Attachment 2

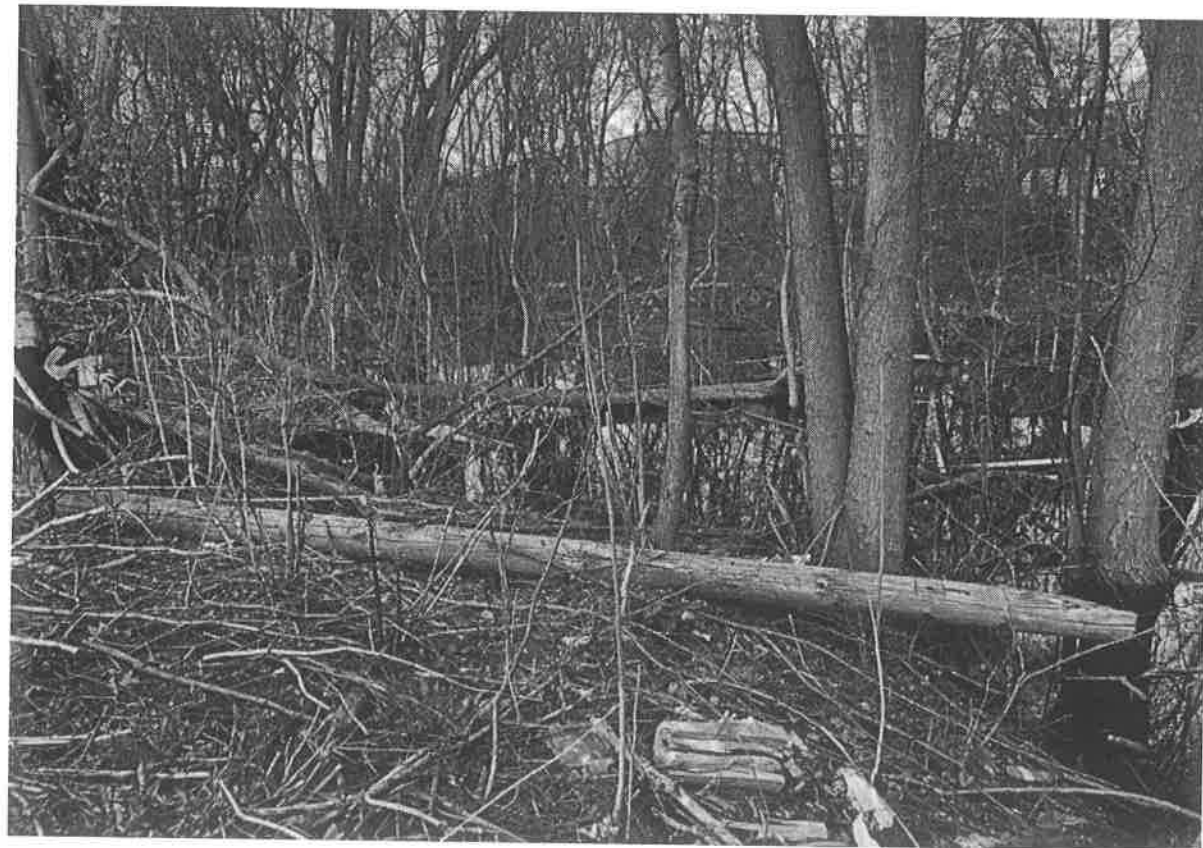
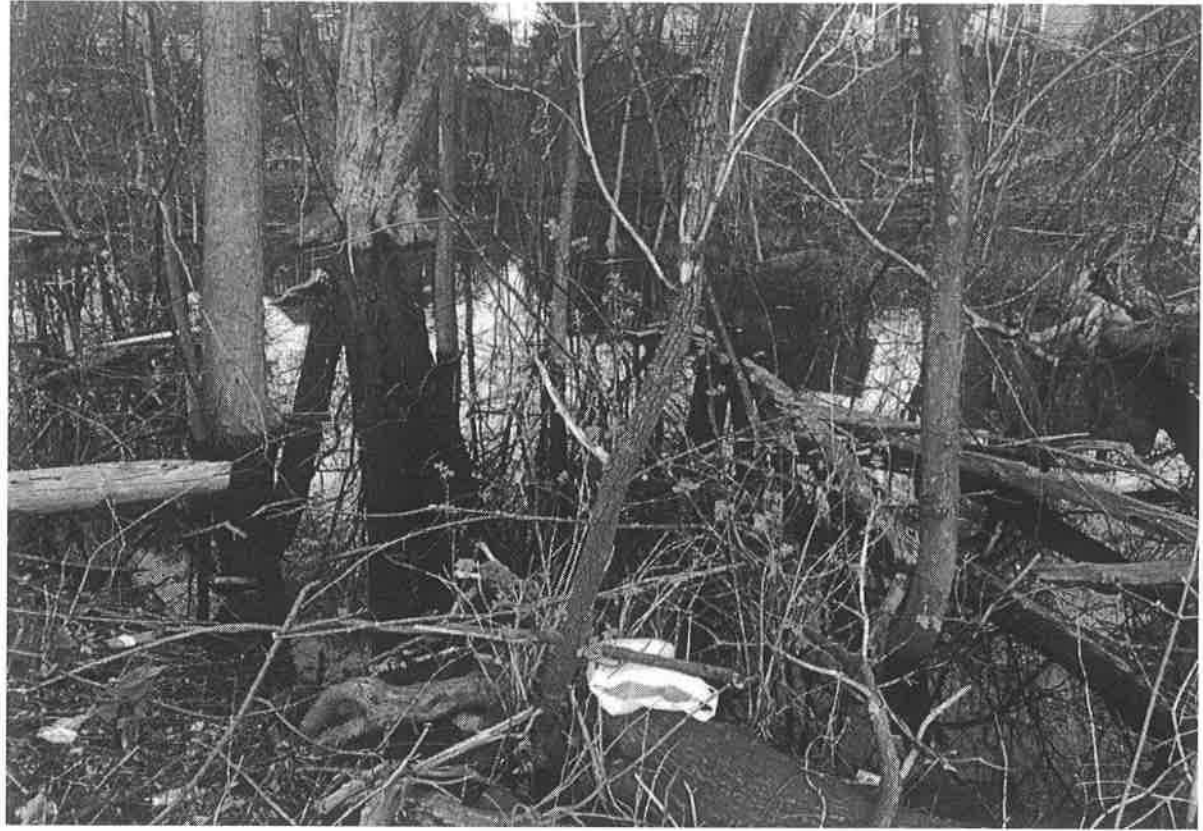
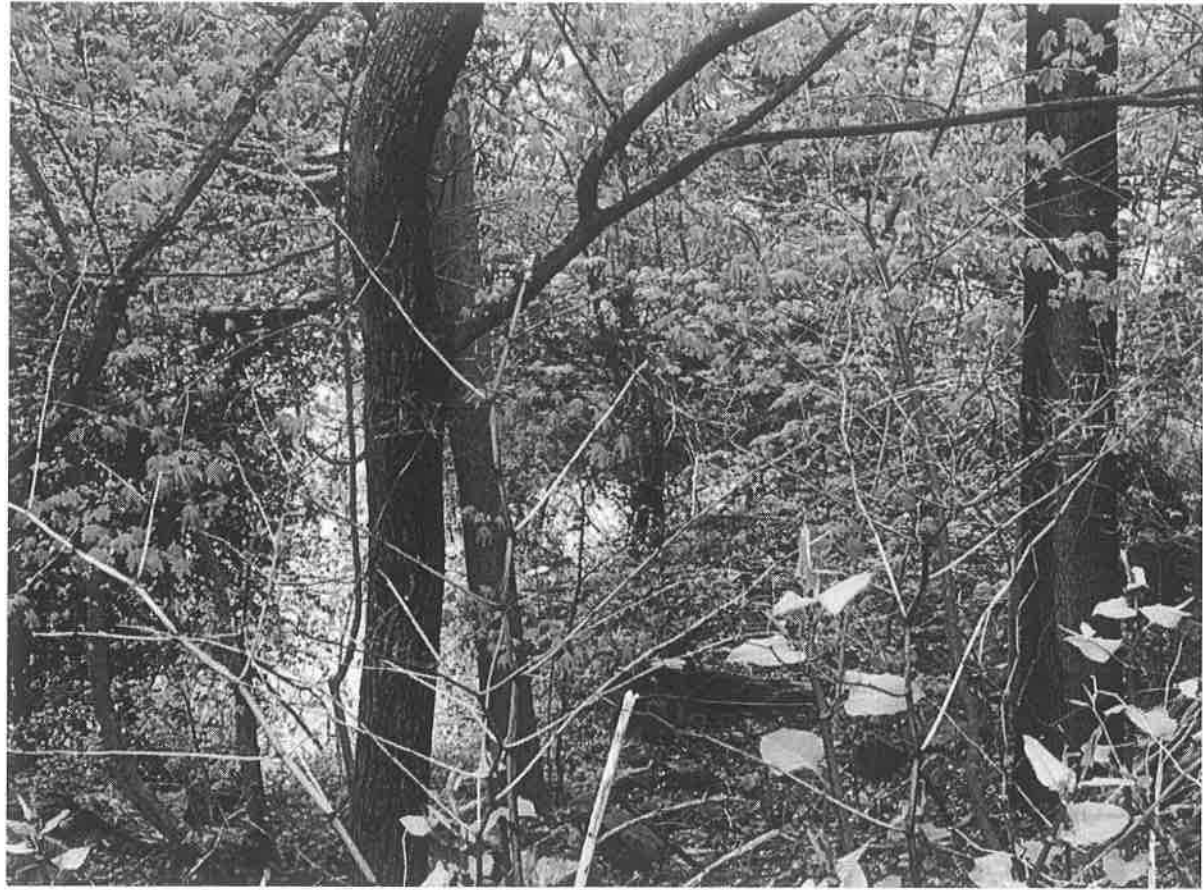
2. The wetland flags with their associated numbers shall be shown on the site plans.

Supplementing the above information from DPS, should there be any question as to the ongoing presence of this wetland, Attachment 2 contains photos taken in 2018 and 2019 of the wetland adjacent to 40 Oak St.
